UNITED STATES PATENT AND TRADEMARK OFFICE

Office Action Summary	Application No. 10/534,837	Applicant(s) PIONTEK, MANFRED	
	Examiner TARLA R. PATEL	Art Unit 3772

DETAILED ACTION

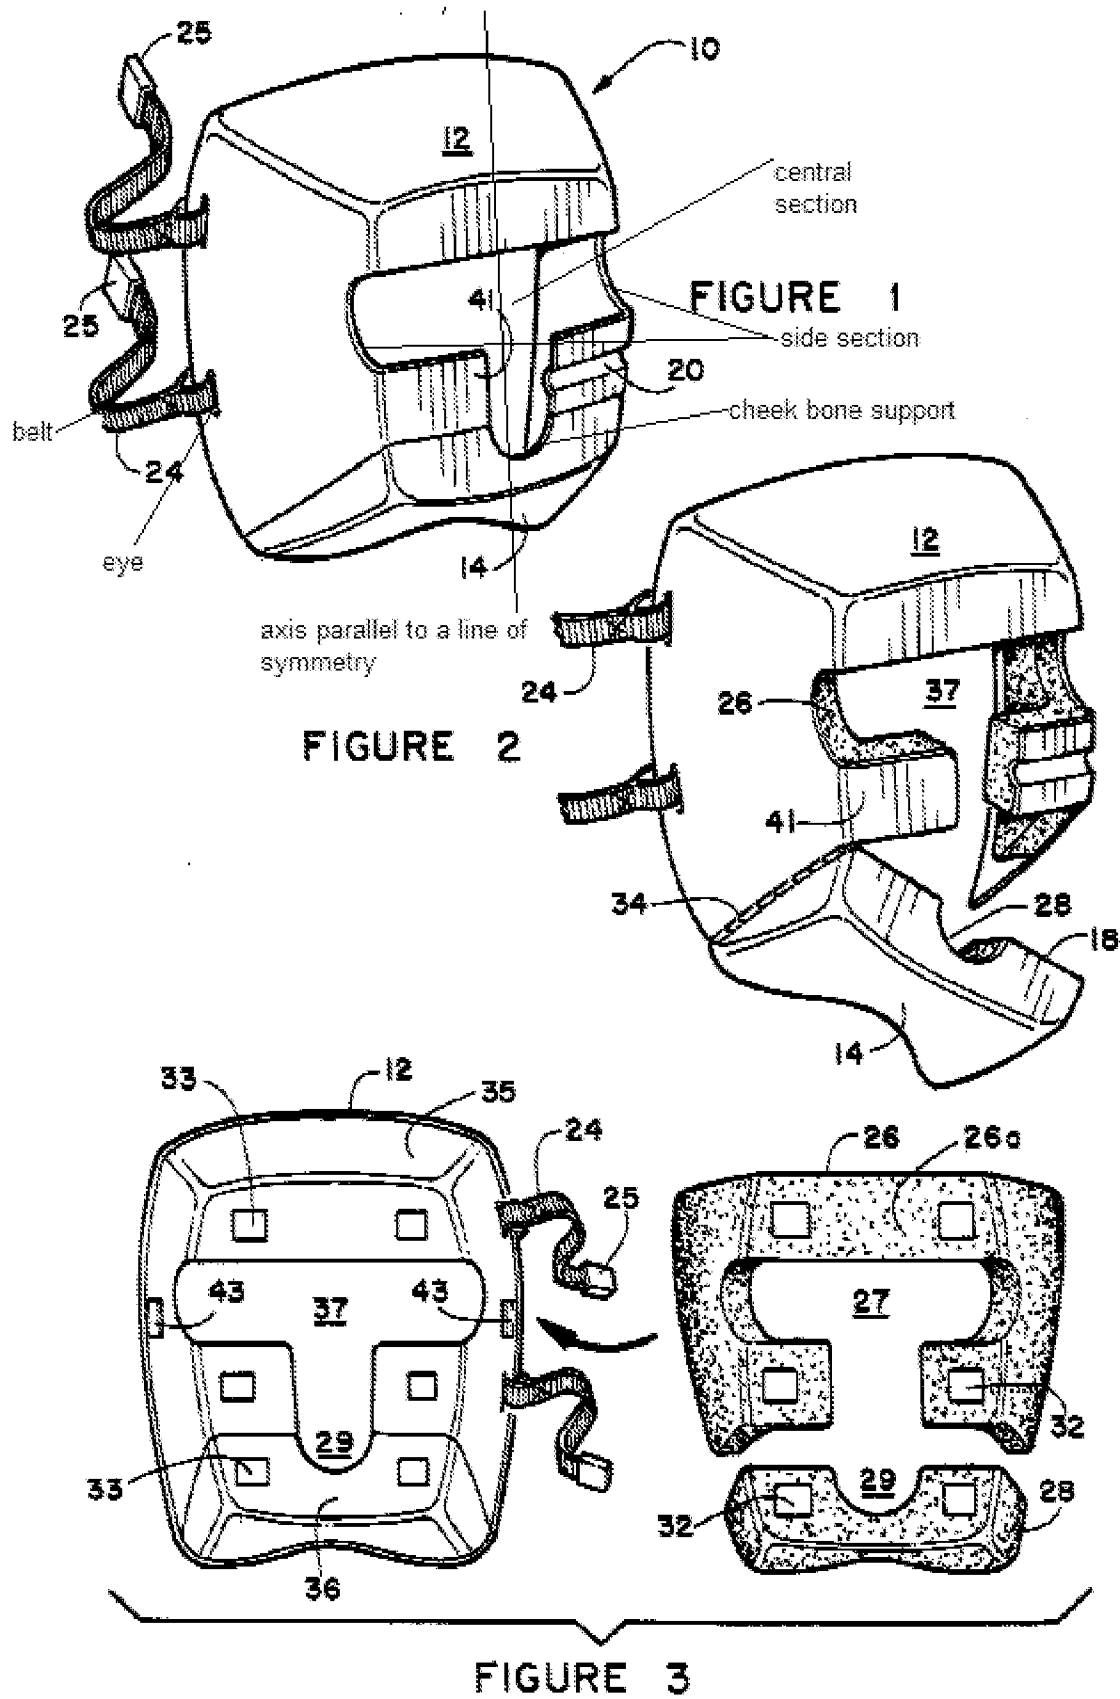
Mazzei disclose a headrest for a patient-bearing surface with rigid-support shell (12, column 5 lines 8-12) and a cushion (26,28) releasably connectable (column 6 lines 36-59) with the rest shell, characterized that the rest shell has an approximately horseshoe-shaped (see fig 1) form with

a central section (37) for supporting the rear or forehead of a head, which central section (37) has a support surface of approximately spherical shell shape, and with two side sections conform at least approximately to a common cylindrical surface whose axis runs parallel to a line of symmetry of the head support running between the side sections with there being a cheekbone (14) on each of the side sections which cheekbone support projects in the direction toward the other side section (see figure below).

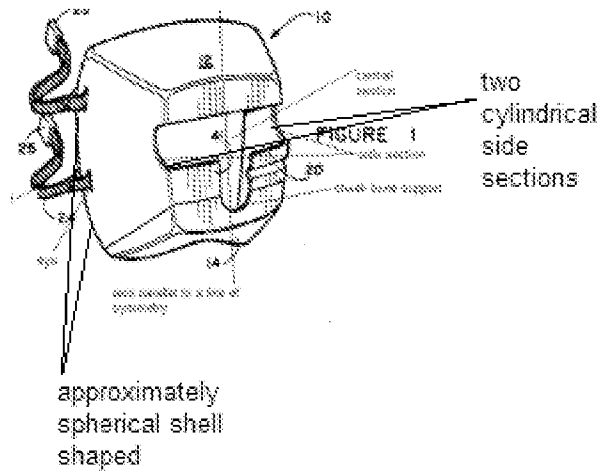
14. Further, applicant argues that the helmet of Mazzei '333 does not disclose a support surface of an approximately spherical shell shape with two cylindrical side sections. A broad interpretation of "approximately spherical shell shaped" has been interpreted to be met by the Mazzei reference since the disclosed helmet can be comprised of two portions that are an approximately spherical shell shaped central sections (see illustrated figure represented below).
